**Subject** ▶ Change on Motor Bracket Complete and Bearing Retainer

**For Models** ▶ 3612, 3612C (Router)

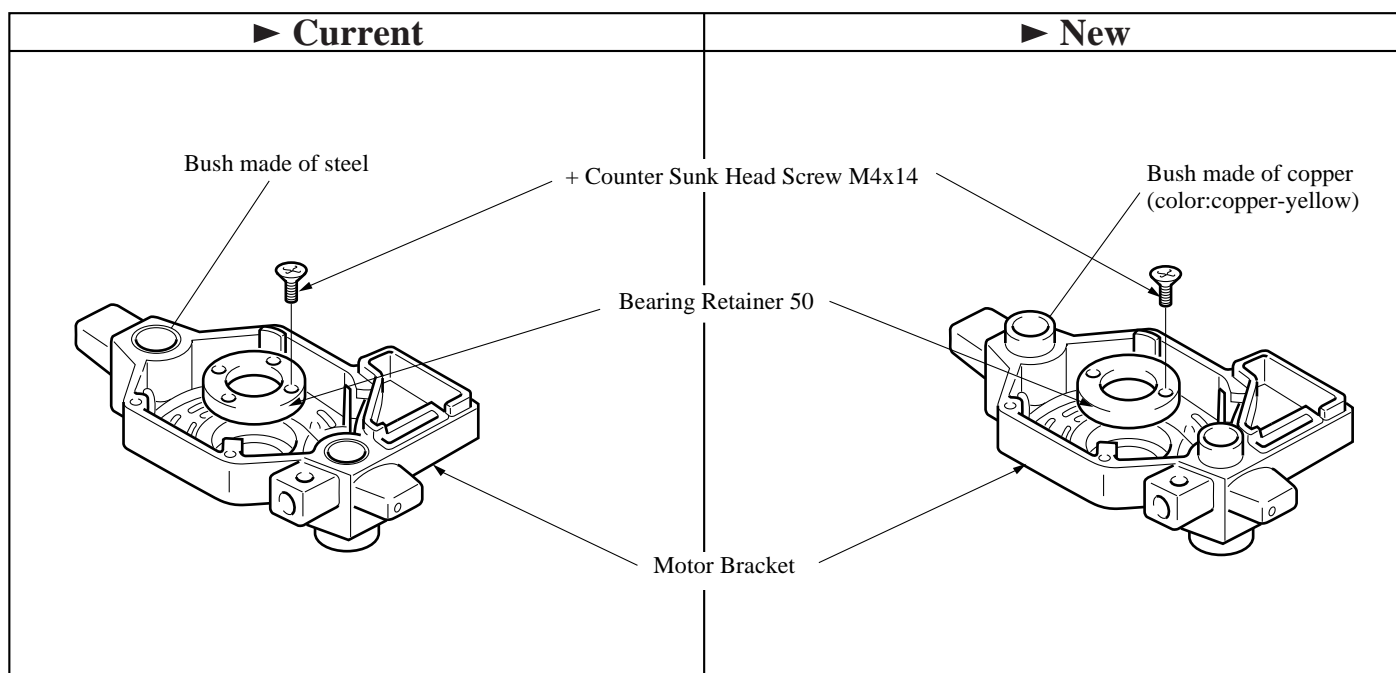
- Description** ▶
- 1) Change of Motor Bracket Complete
    - ; Bushes inlaid at Motor Bracket have been changed from steel to copper and lengthened. for smoothing up and down operation.
  - 2) Change of Bearing Retainer
    - ; Screws for fixing Bearing Retainer has been reduced from four to two.
    - Accordingly holes of Bearing Retainer for screws have been reduced from four to two.
